BAR Meeting
May 15, 2013

ISSUE: Permit to Demolish/Capsulate and Certificate of Appropriateness for Alterations/Signage

LOCATION: 605 Franklin Street

BAR2013-00124

PROPOSED SOUTH ELEVATION
 1/4" = 1'-0"

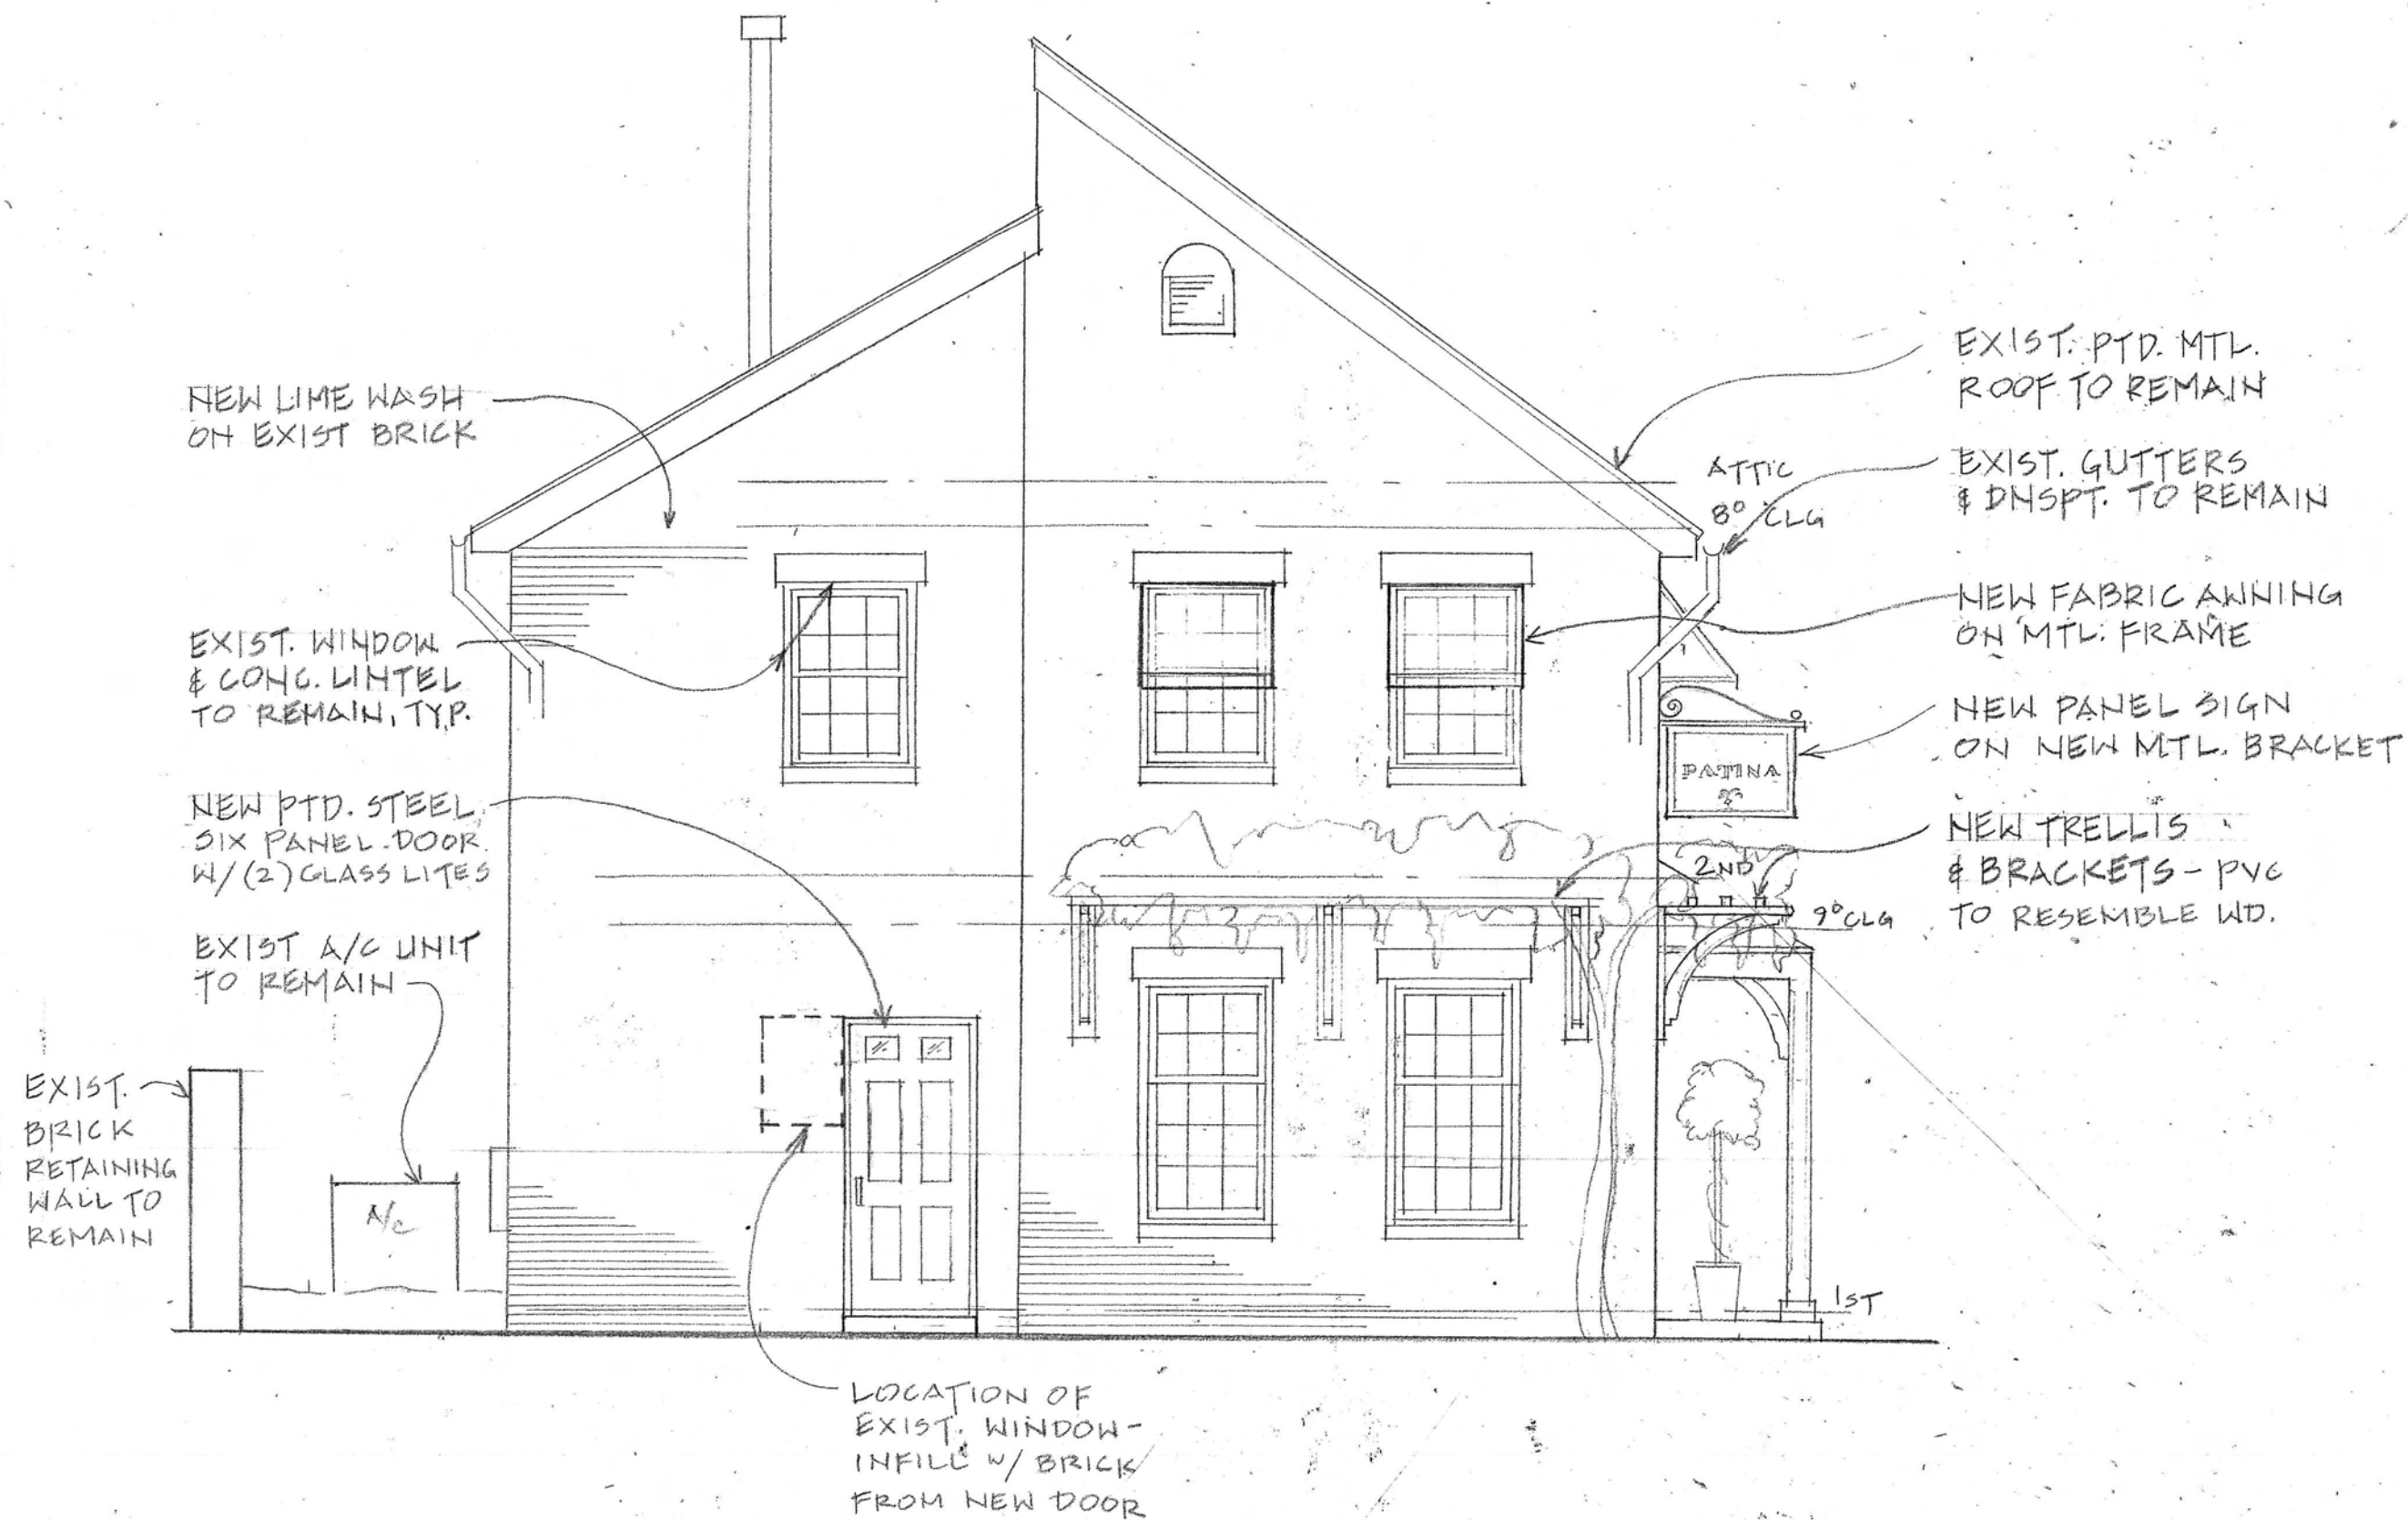
1. That the new wood gate is painted or stained.
2. That the color and material of the fabric awnings are submitted to BAR staff for review and approval prior to issuance of the Building Permit.
3. That the proposed SDL painted wood windows will comply with the BAR's adopted Window Policy.

- Replace existing half-glass, two-panel entry door with a new, painted wood, single-light entry door.
- Removal of single light fixture at front entry and replace with two (2) wall, mounted, lantern-style, light fixtures to flank entry door.
- Installation of a 6' high, wood, gate affixed to the existing brick wall enclosing the east side yard.
- Remove existing wood columns on front entry portico and replace with new, painted wood columns and brackets.
- Install fabric awnings above second floor windows.
- Install a new bracketed, PVC trellis above the first floor windows.

PROPOSED WEST ELEVATION
 1/4" = 1'-0"

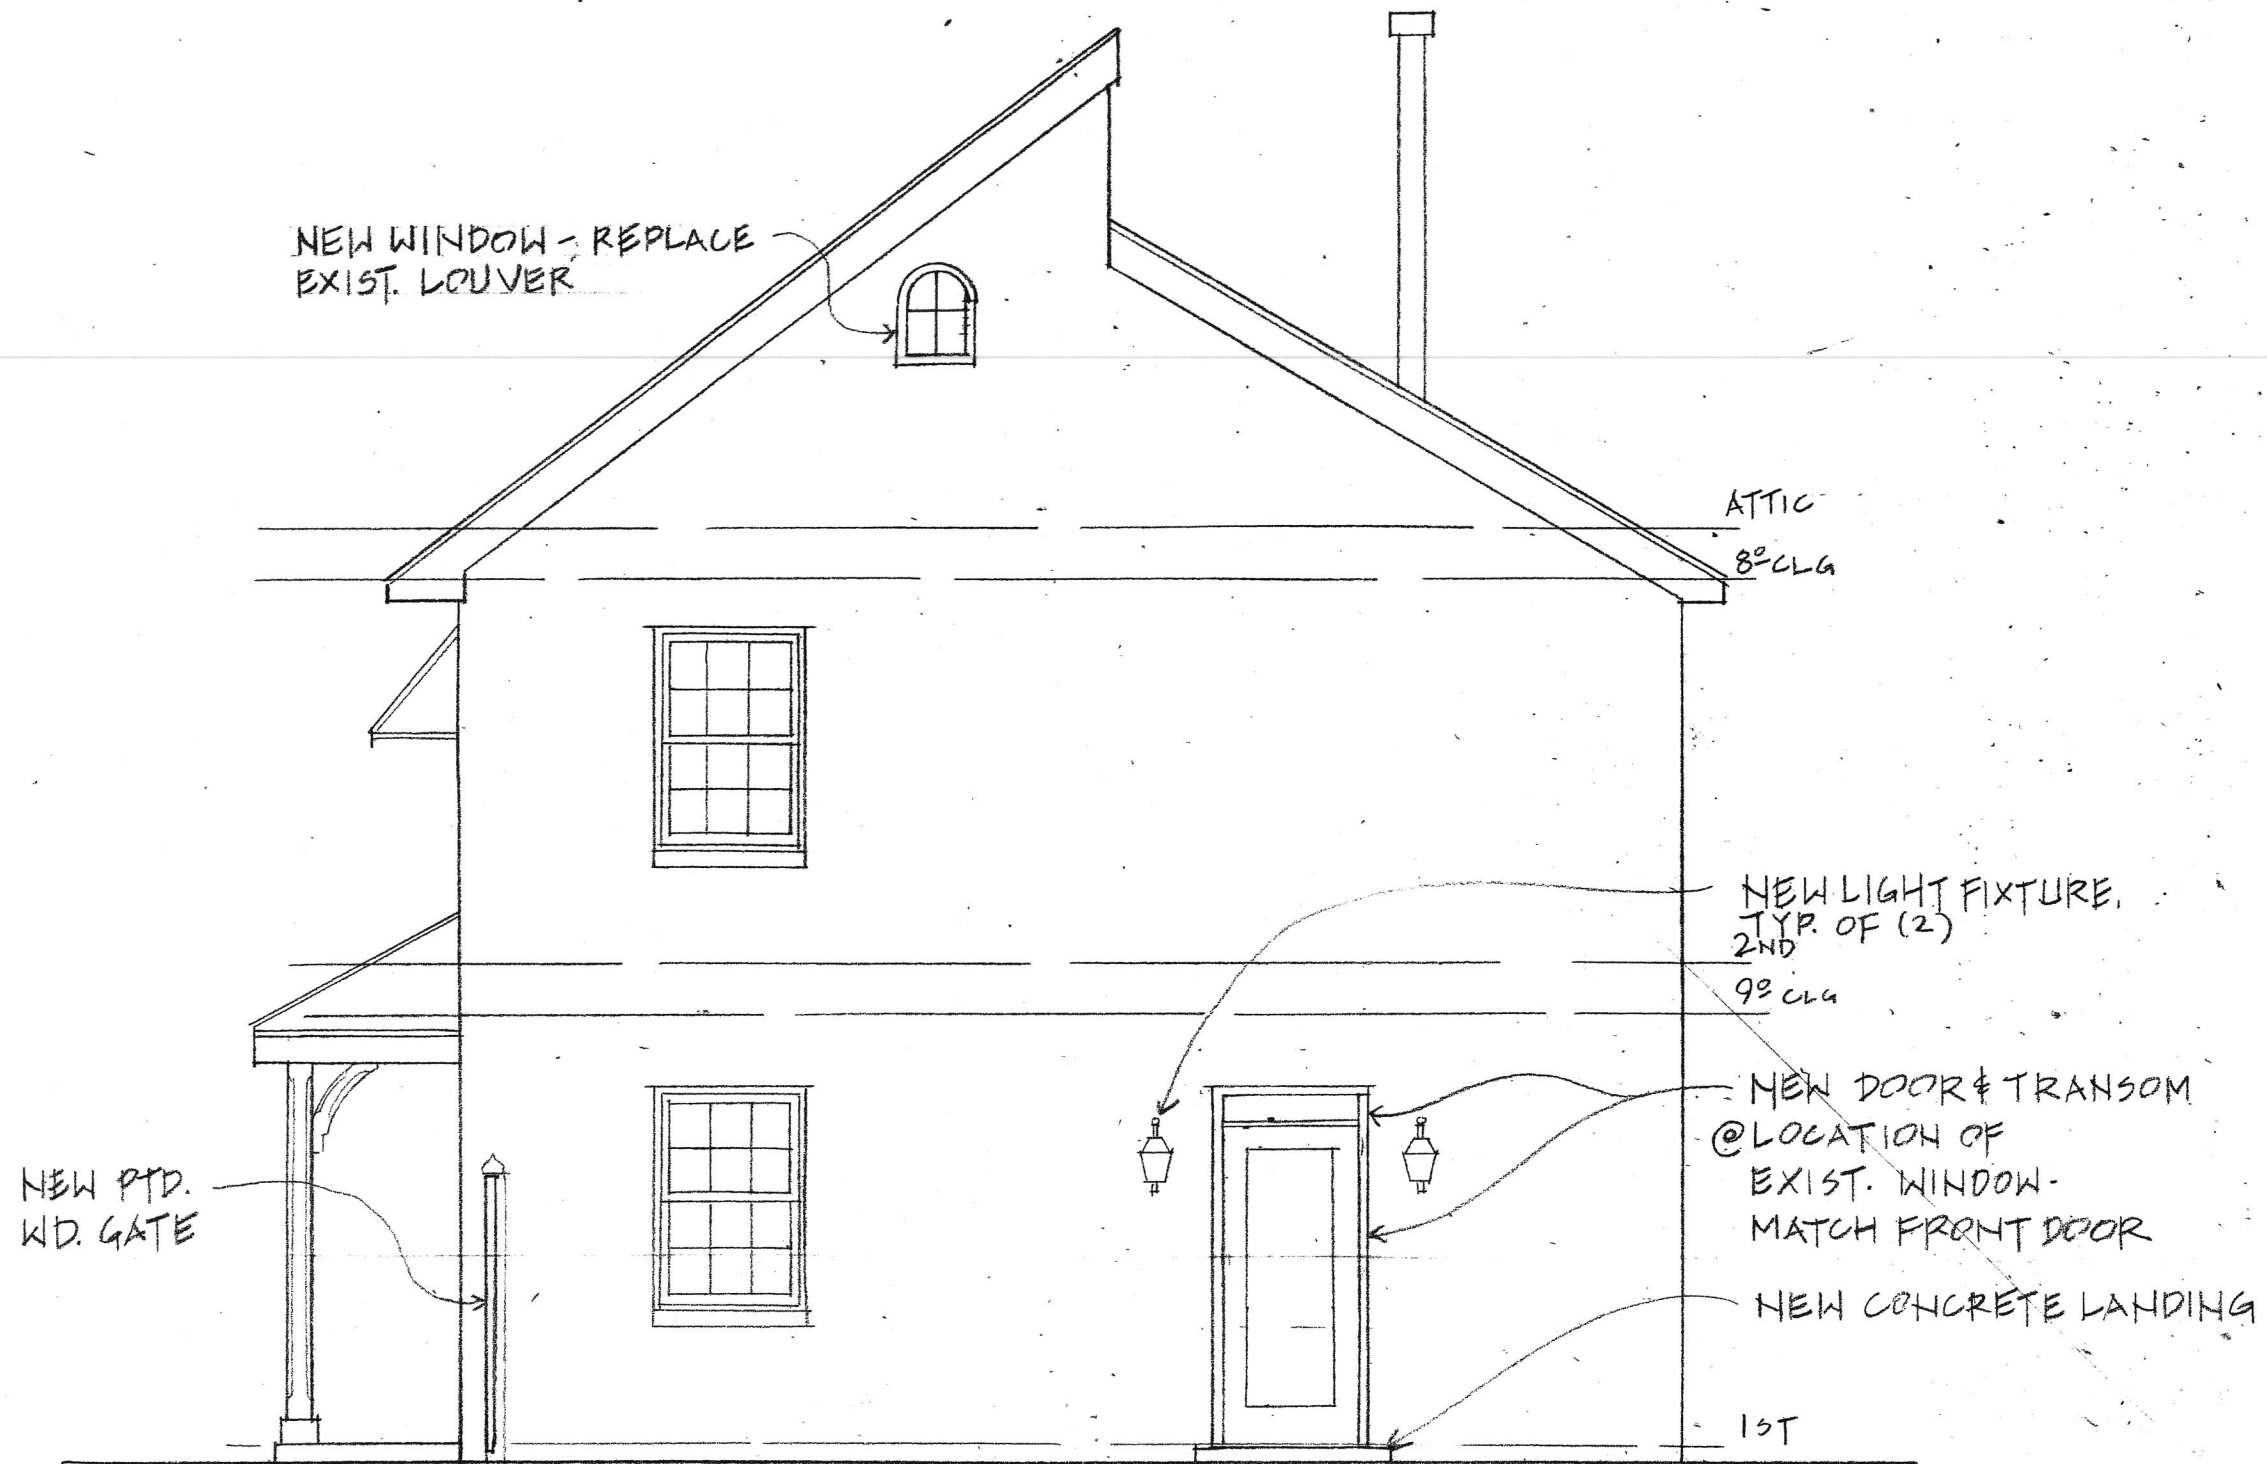
- Demolition of approx. 21 sq. ft. of wall area, including an existing window, to install a painted steel, six-panel door with glazed top panels.

- Install a new bracketed, PVC trellis above the first floor windows.
- Install fabric awnings above second floor windows on the main massing.
- Install a painted steel, six-panel door with glazed top panels.
- Install a wall, mounted, lantern-style, light fixture with motion-sensor to the left of the new entry door.
- Remove and replace the existing third floor louver with an arched, four-light SDL, painted wood window.

PROPOSED EAST ELEVATION

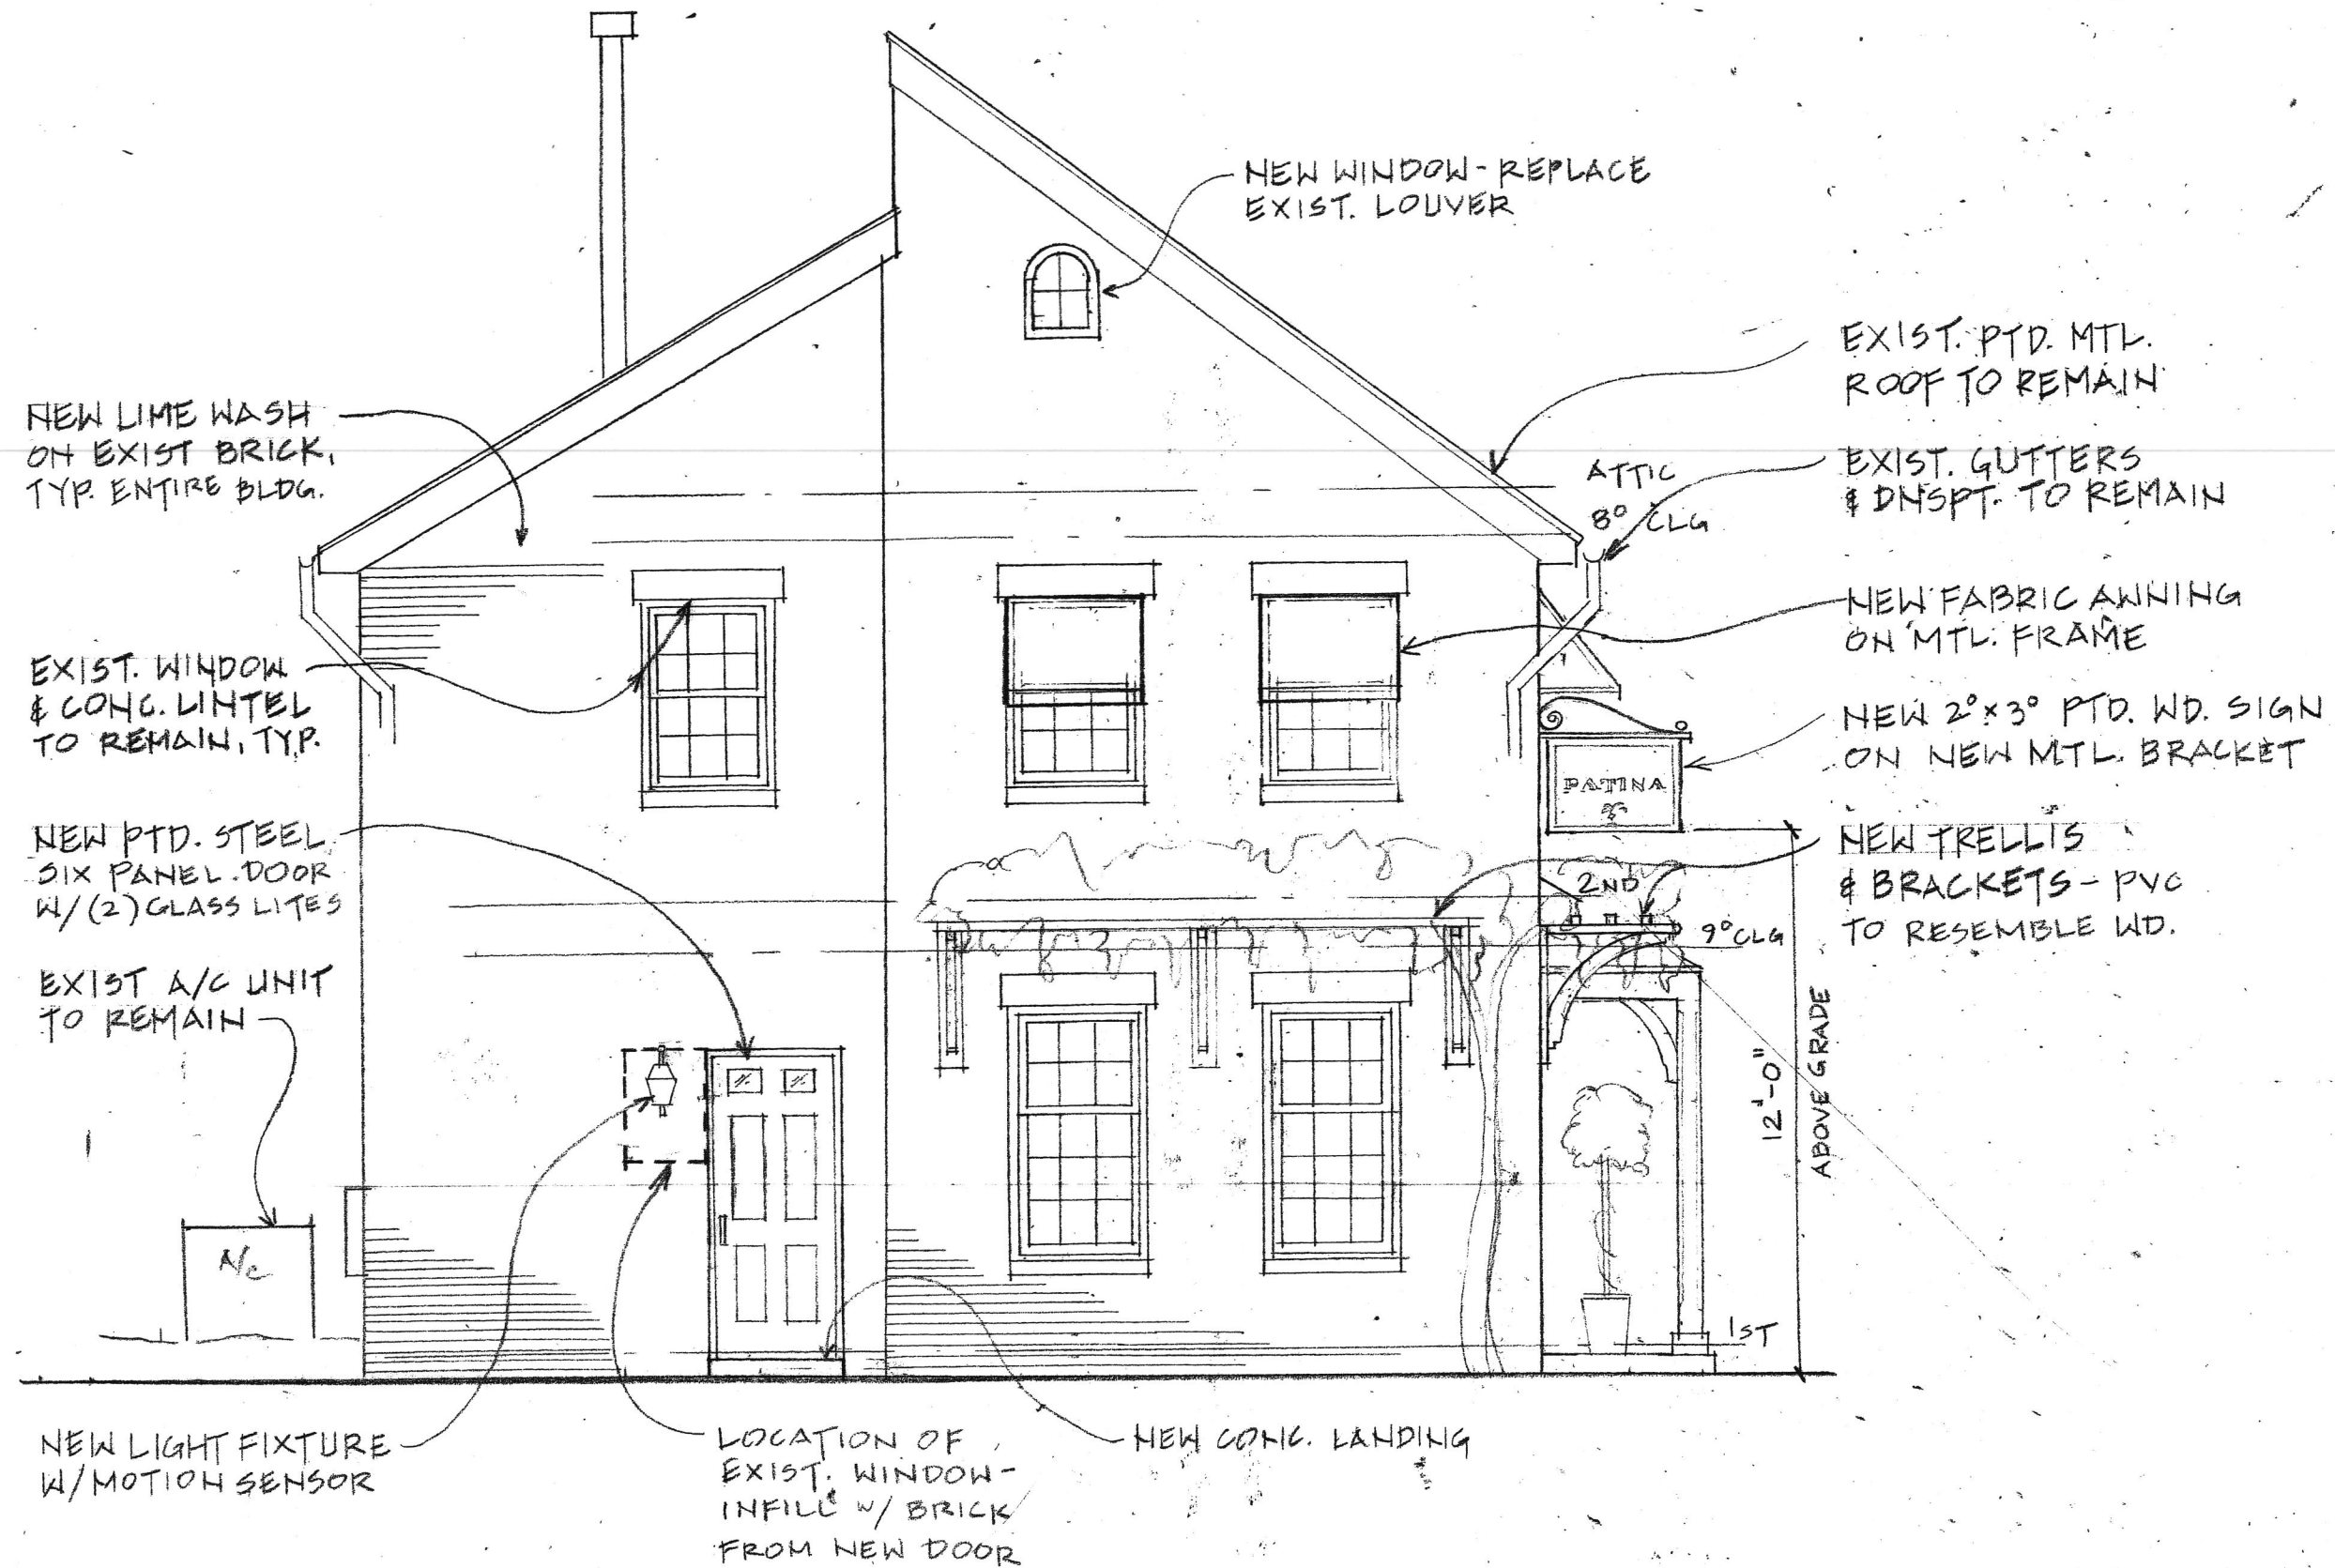
- Demolition of approx. 8 sq. ft. of wall area below existing window to install a new, a new, painted wood, single-light entry door with single-light transom.

- Remove and replace the existing third floor louver with an arched, four-light SDL, painted wood window.
- Install a new, painted wood, single-light entry door with single-light transom.
- Install two (2) wall, mounted, lantern-style, light fixtures to flank entry door.
